**BID ADDENDUM NO. 5**

Date of Addendum: April 24, 2026  
Issued for Bid Date: March 27, 2026  
Client Name: Public Schools of the Tarrytowns  
Project Name: 2024 Capital Bond Project – Phase 2; Washington Irving Intermediate School  
SED Project No.: 66-04-01-03-0-002-017  
TUFSD Bid Number: 25/26-TUFSD-003  
MEMASI Project No.: 101-2403  
Contracts: Contract 1: General Construction (GC)  
Contract 2: Mechanical Construction (MC)  
Contract 3: Electrical Construction (EC)  
Contract 4: Plumbing Construction (PC)

**DEMOLITION PART PLANS - FIRST AND SECOND FLOOR AREA A**

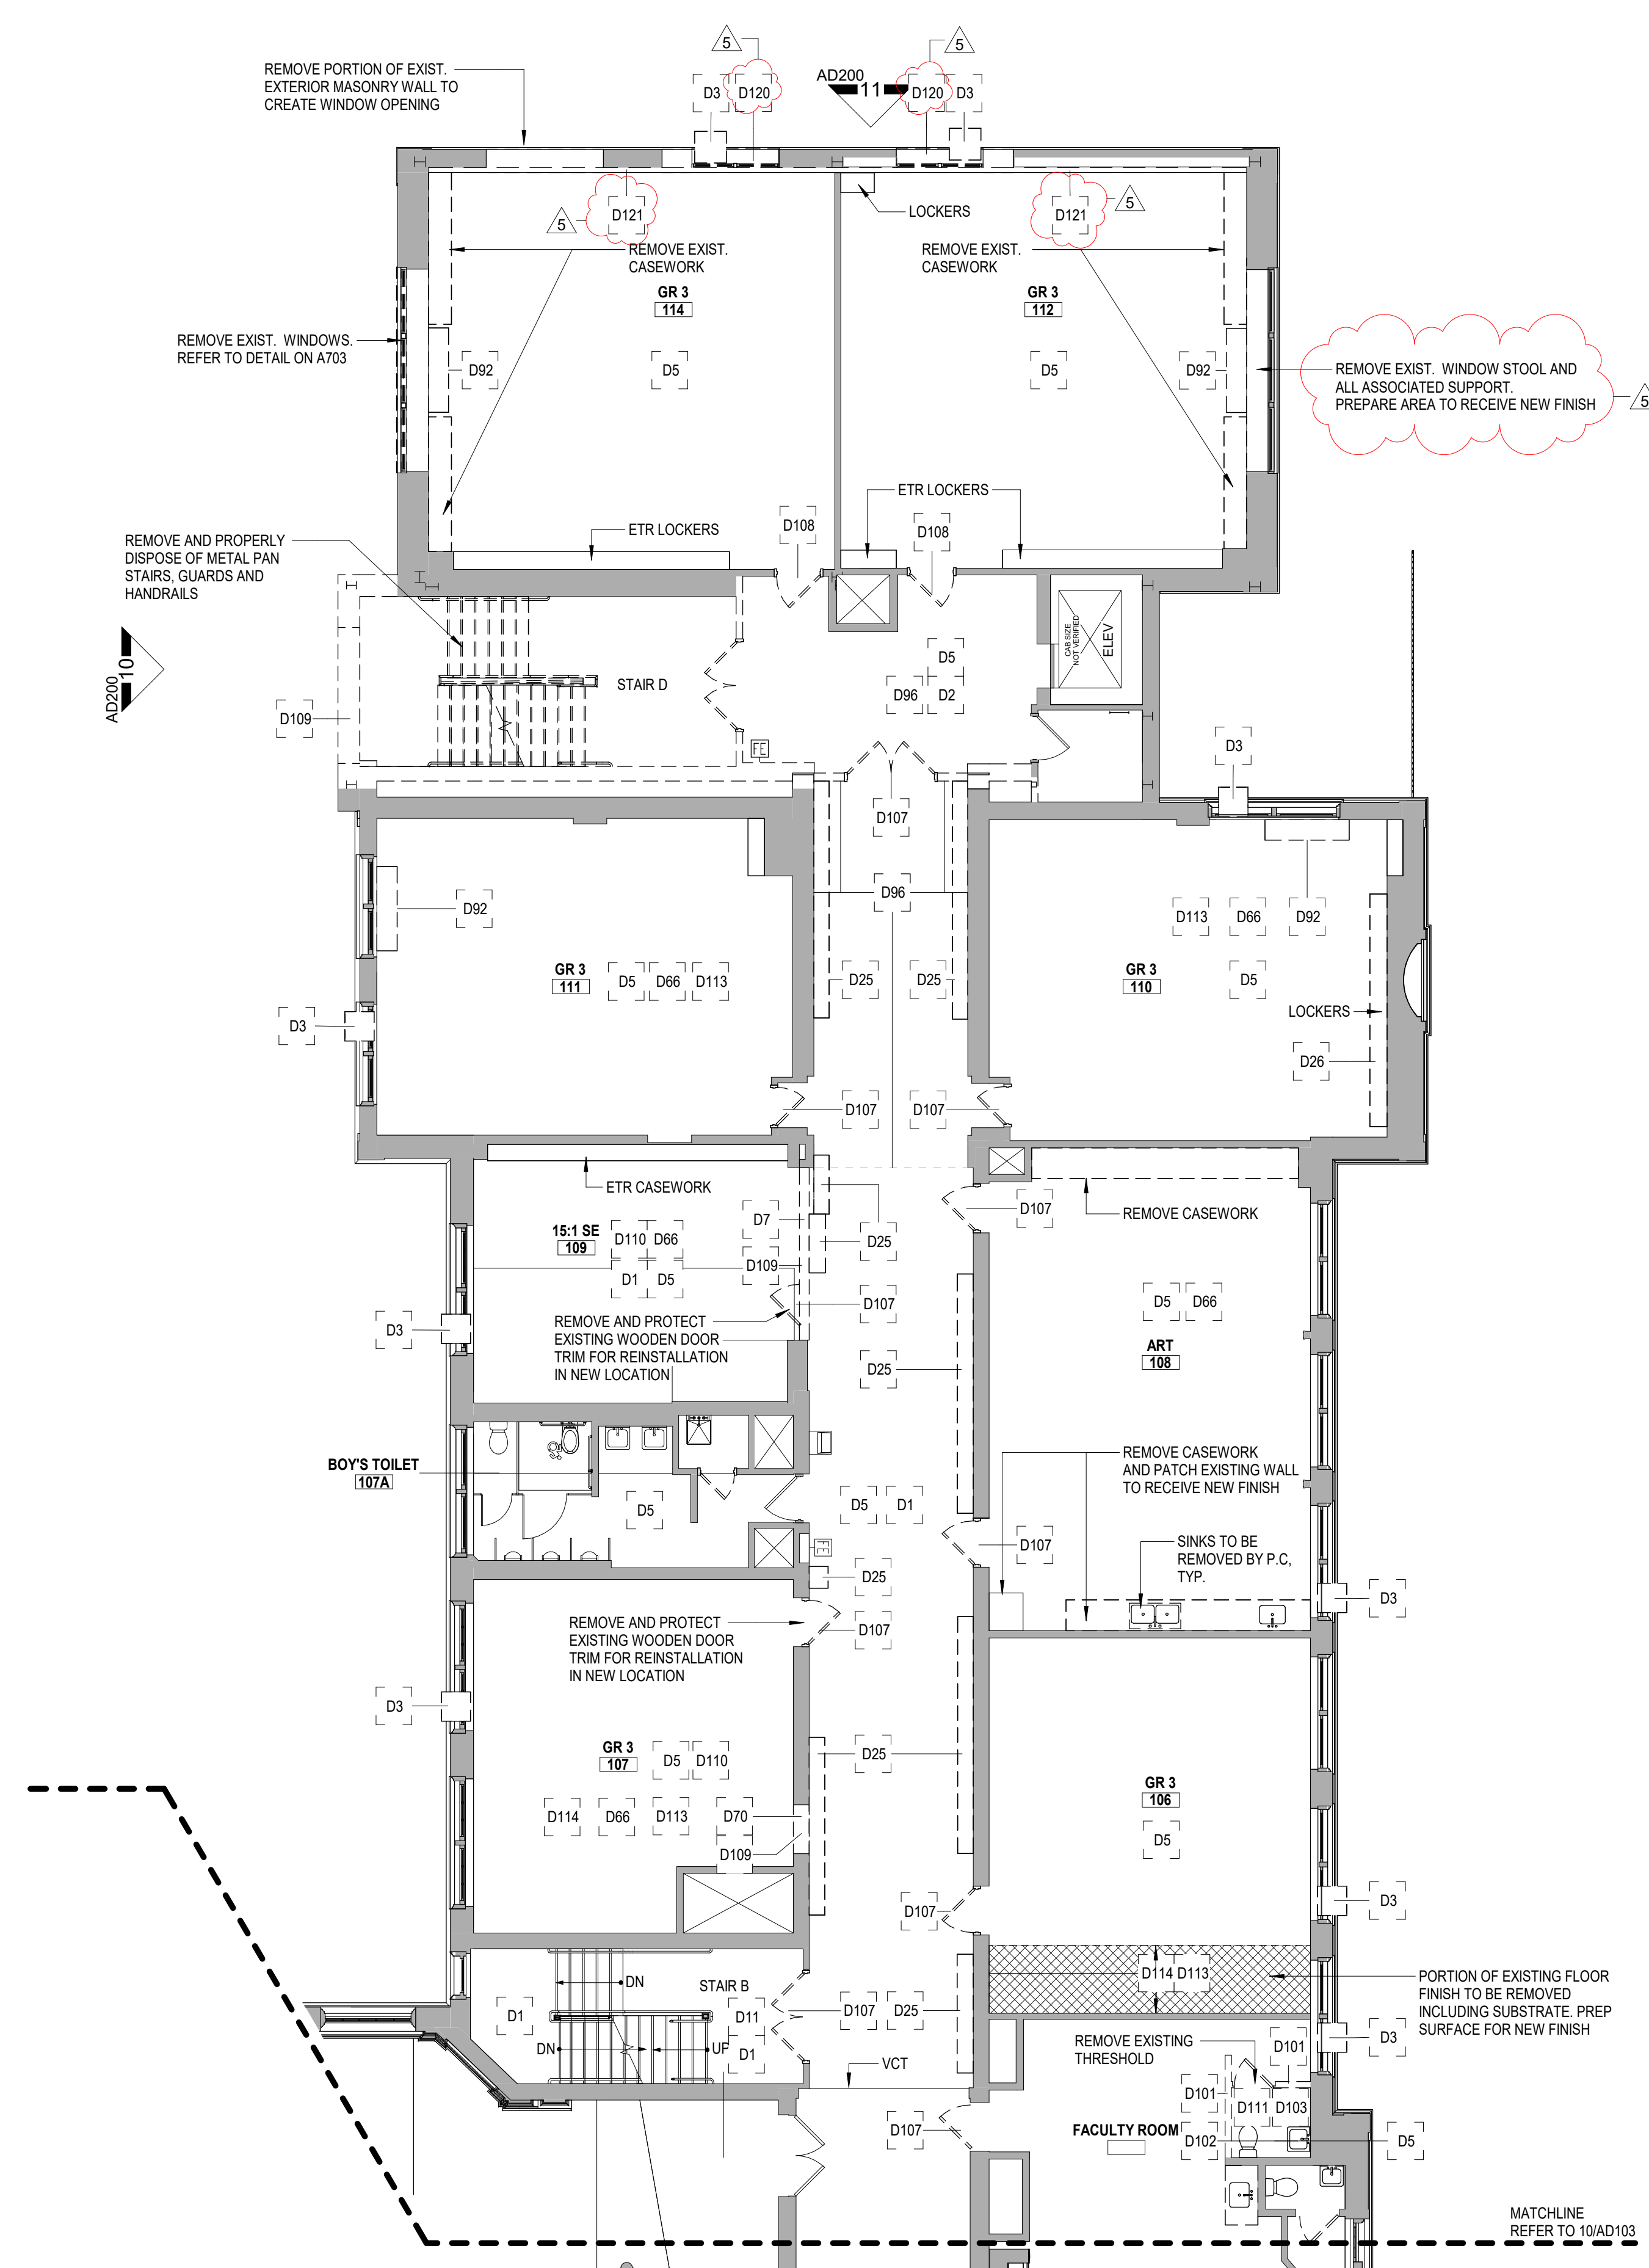
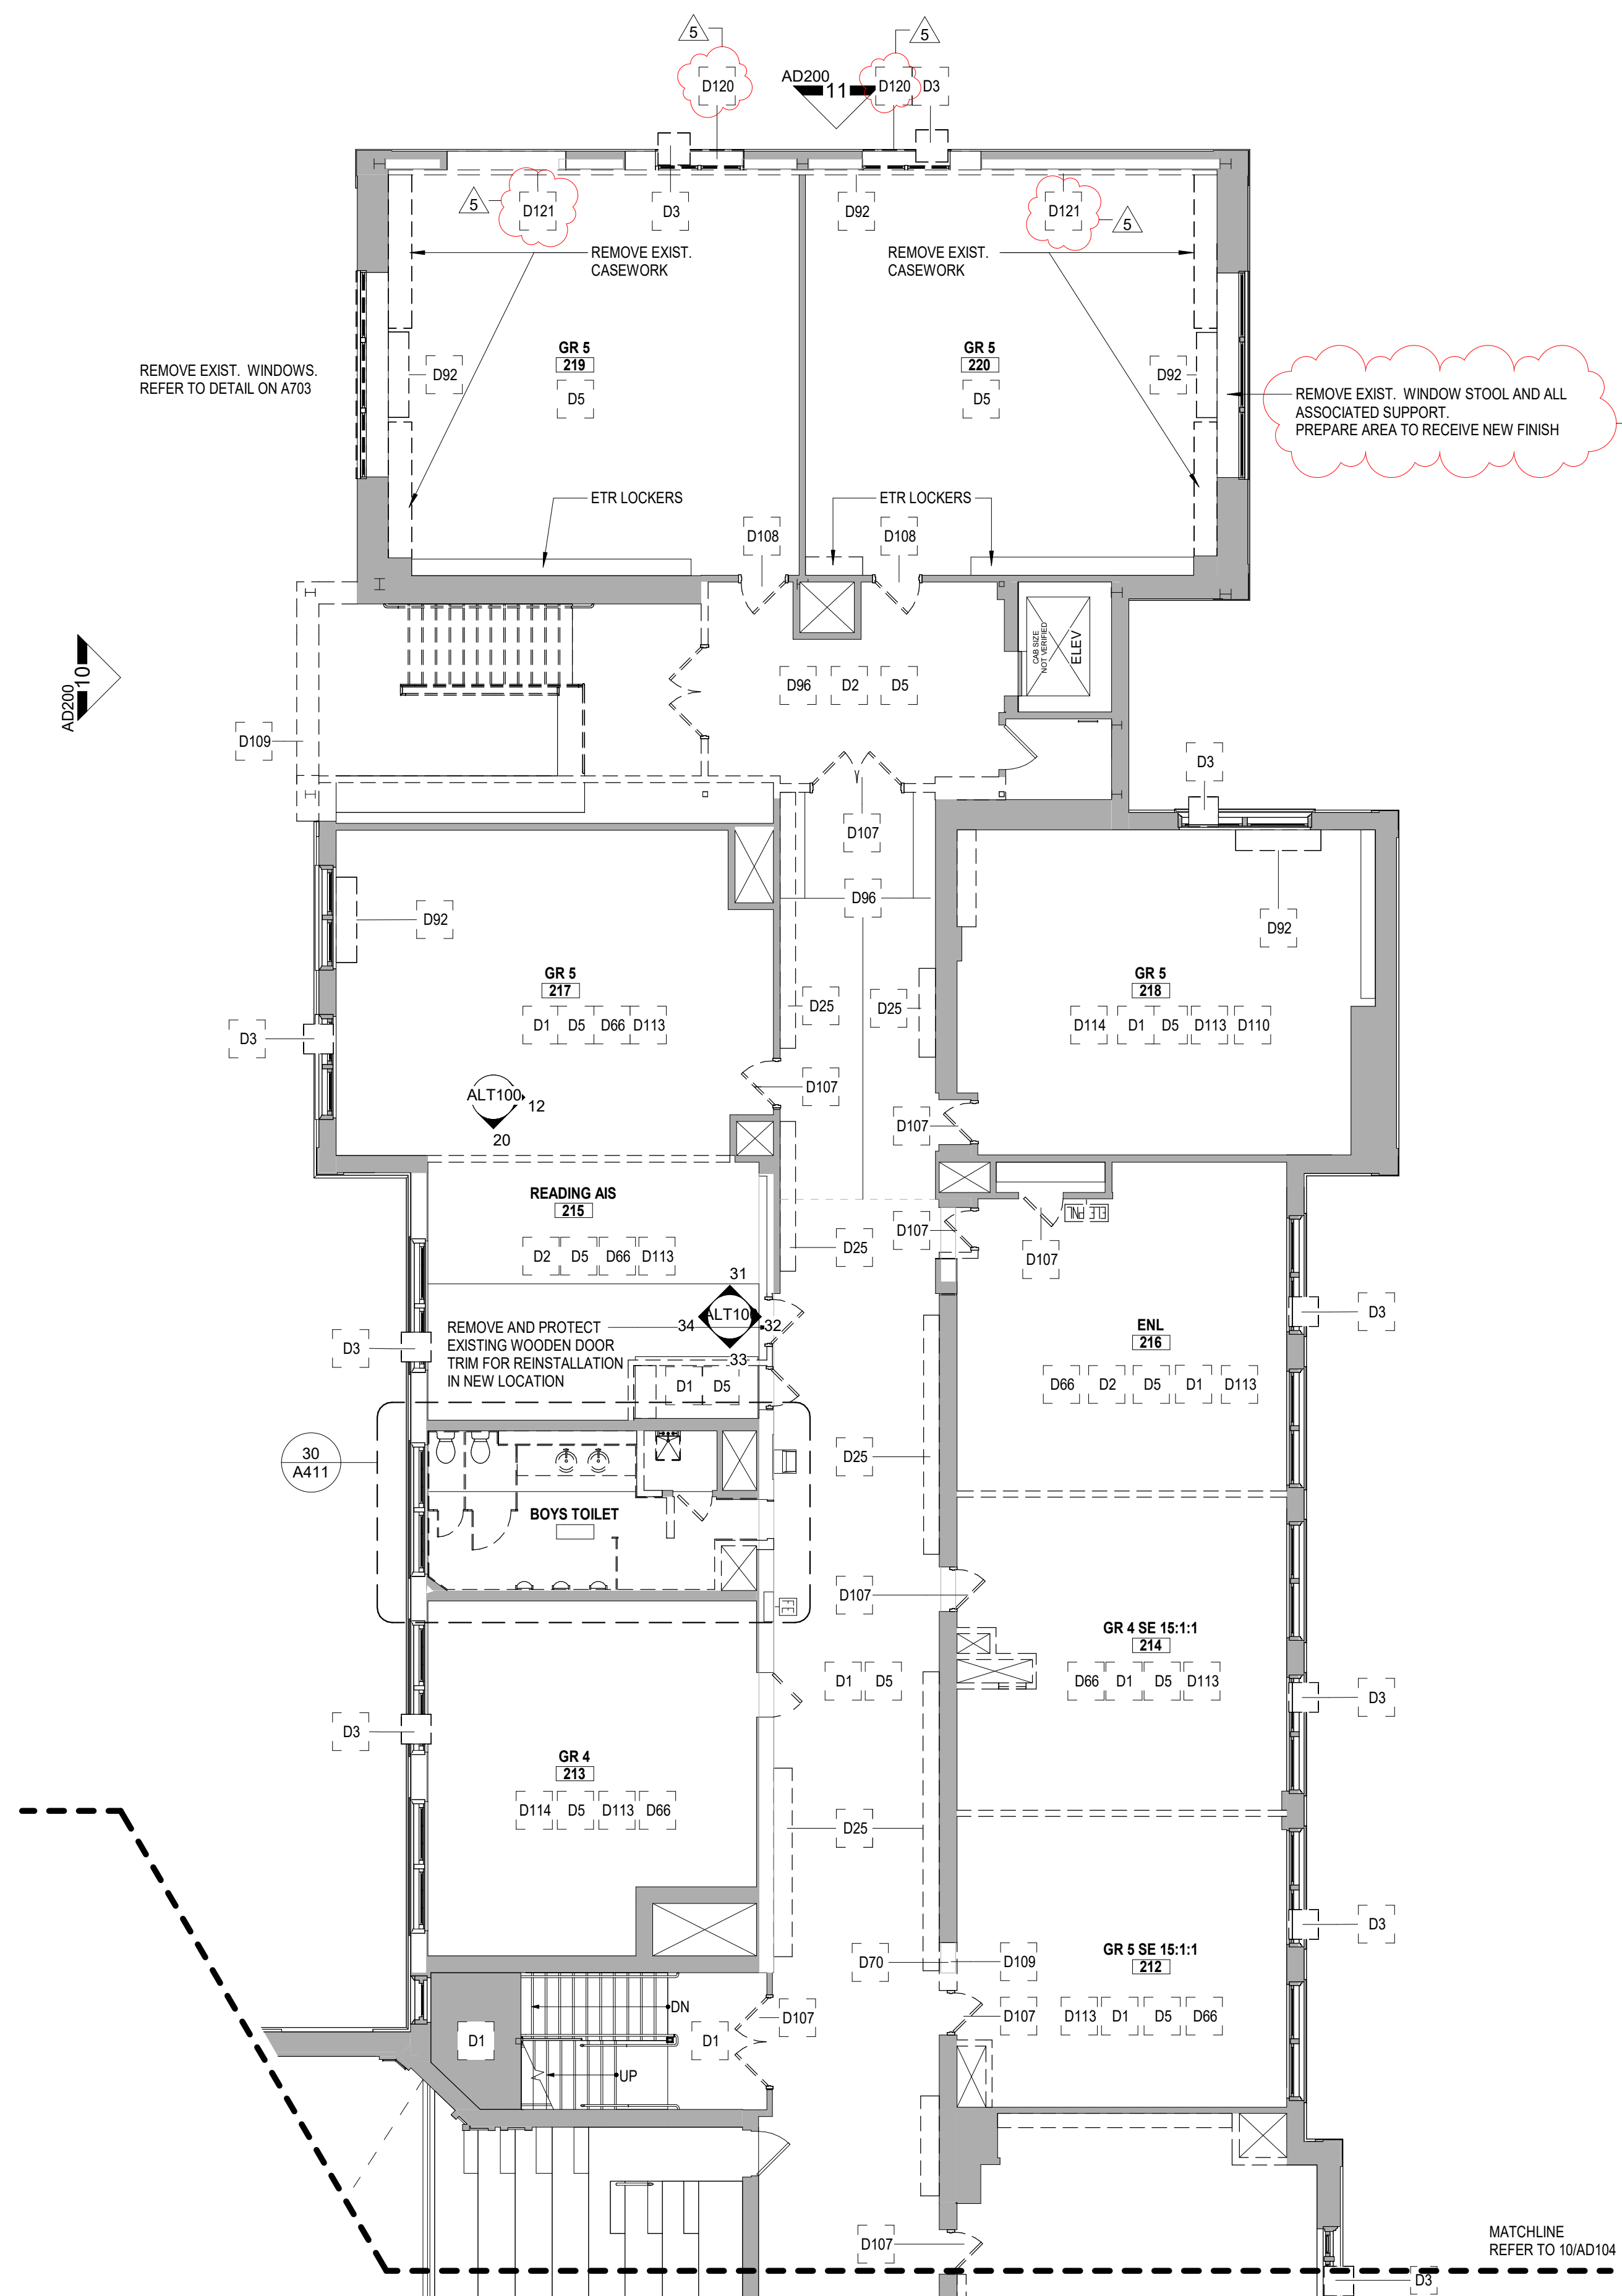
- b. SHEET AD102-A – DEMOLITION PART PLANS – FIRST & SECOND FLOORS AREA A; DELETE existing sheet AD102-A. ADD Sheet AD102-A, revised 4/24/2026, attached.

**1. BASEMENT FOUNDATION PLAN - AREA A**

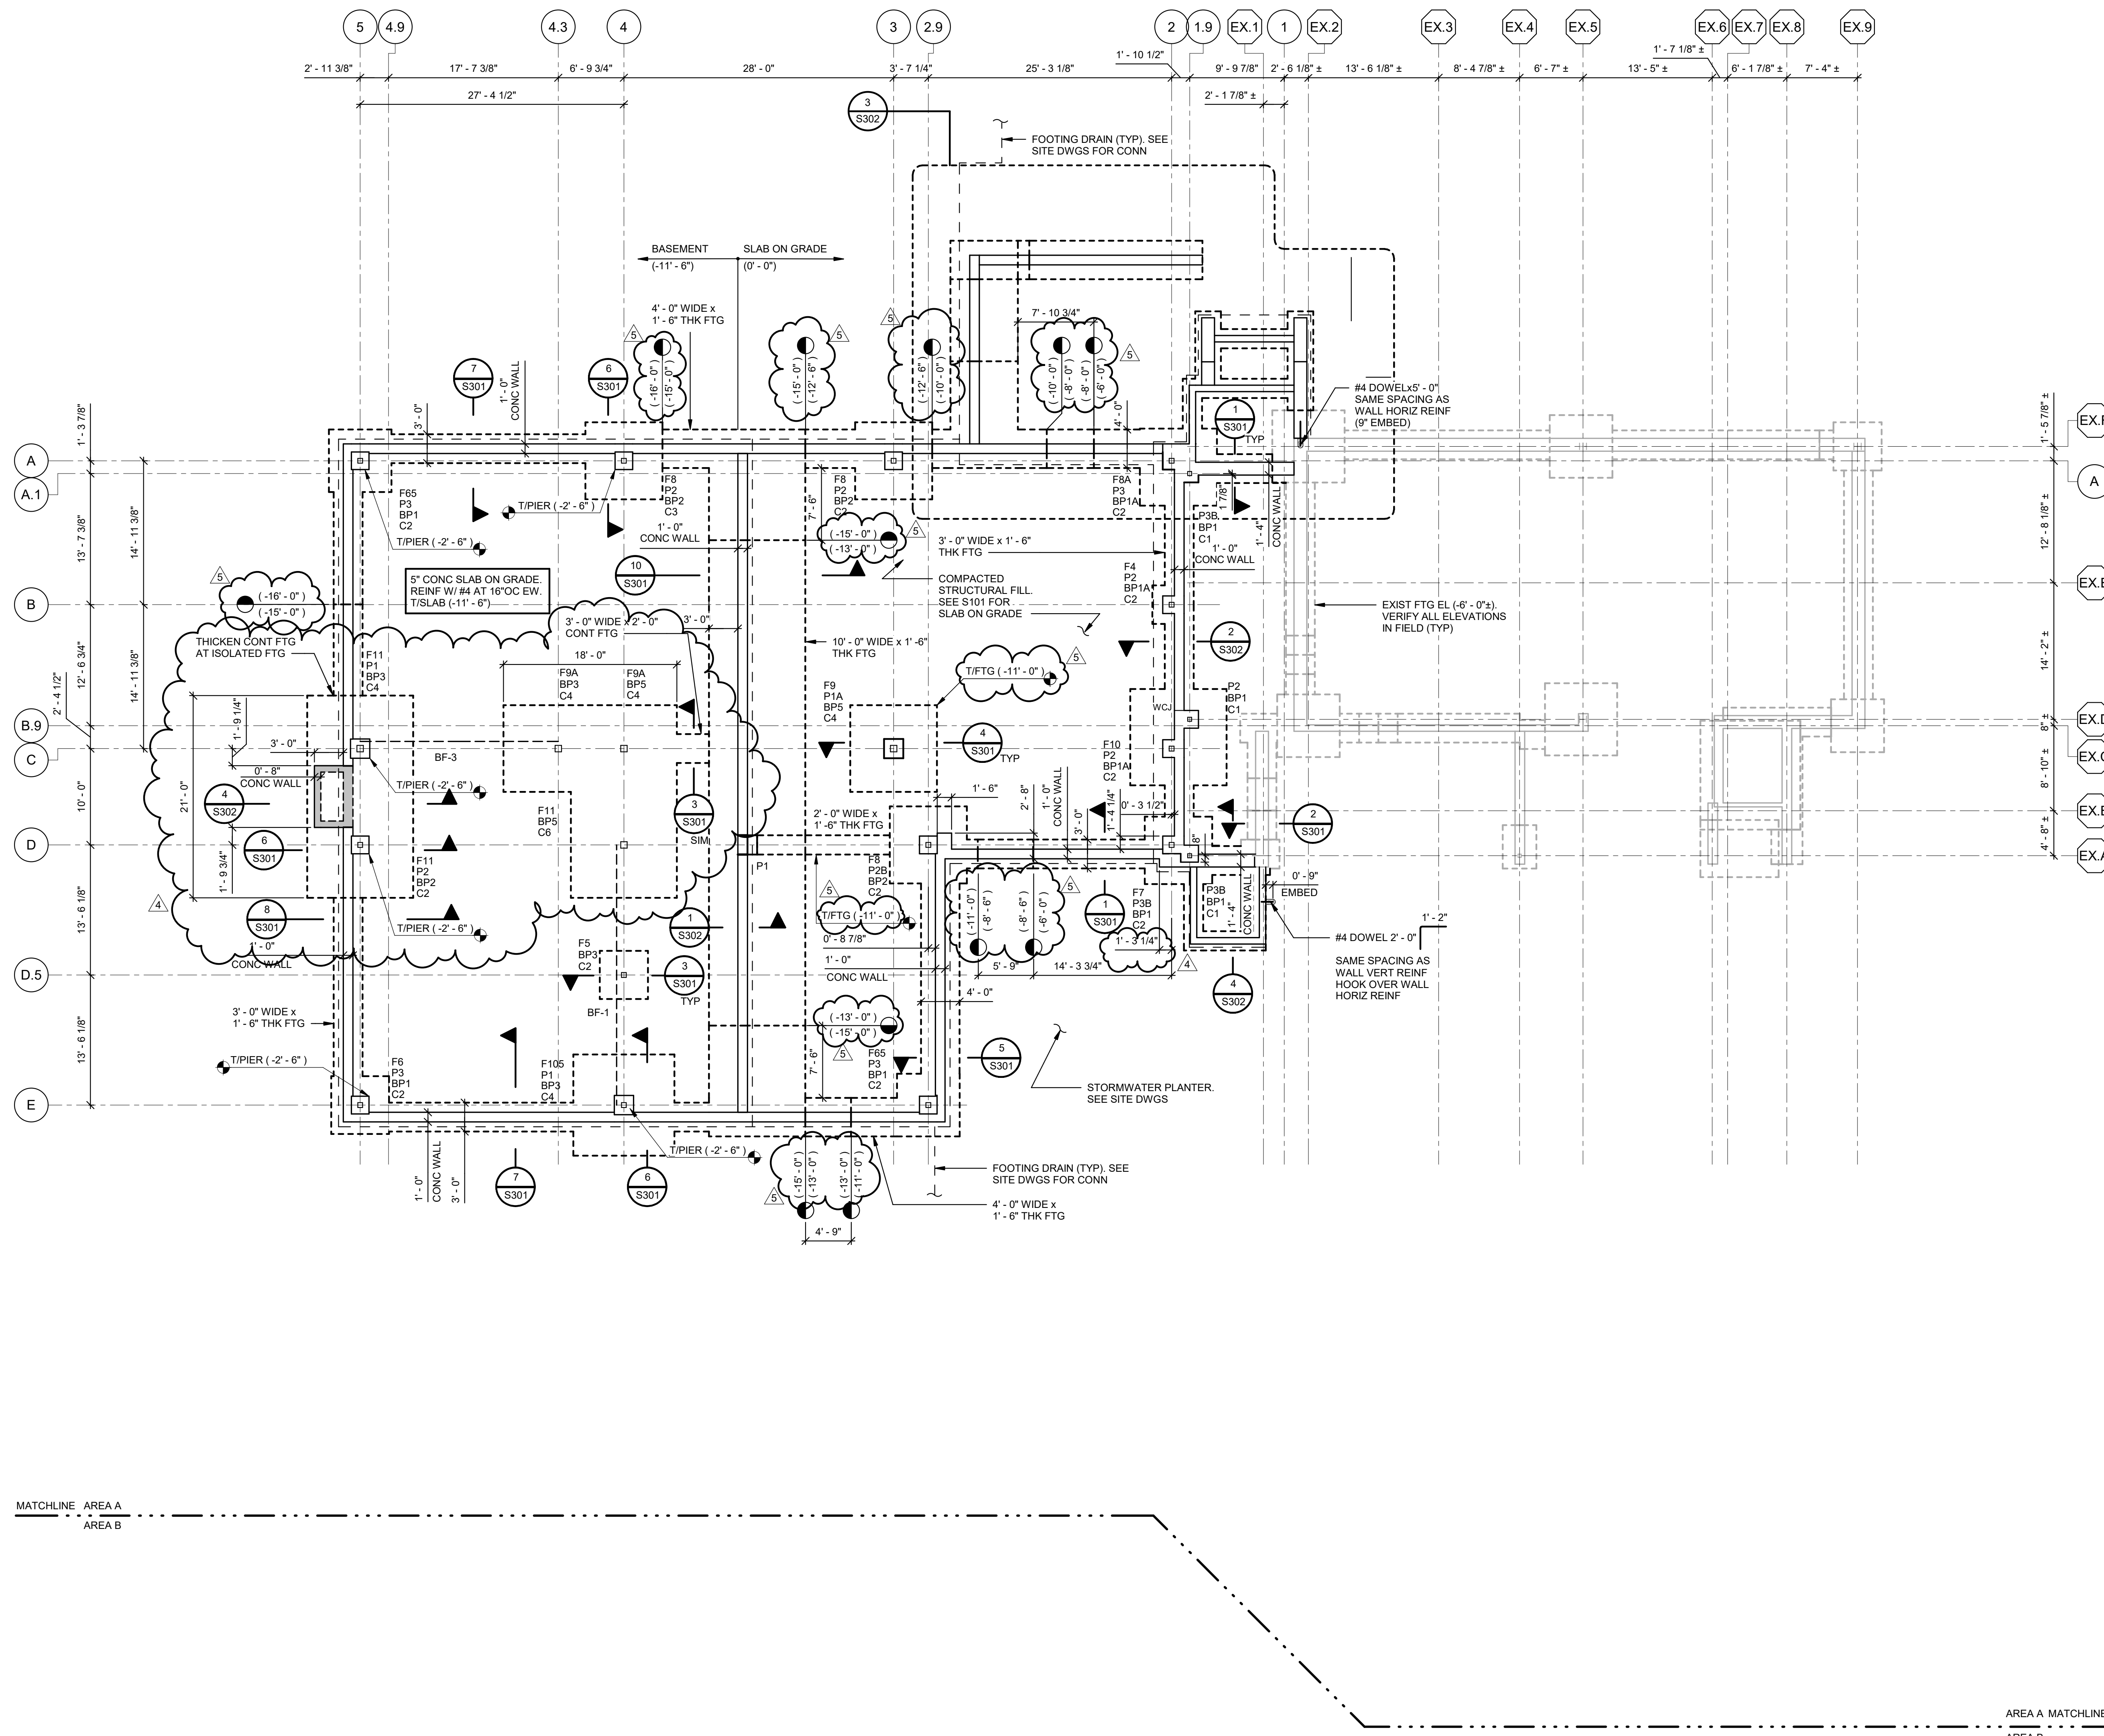
- o. SHEET S100 – BASEMENT FOUNDATION PLAN – AREA A – DELETE Sheet S100, dated 03/27/2026. ADD Sheet S100, revised 4/23/2026, attached.
- p. SHEET S101 – GROUND FLOOR FRAMING PLAN – AREA A – DELETE Sheet S101, dated 03/27/2026. ADD Sheet S101, revised 4/23/2026, attached.
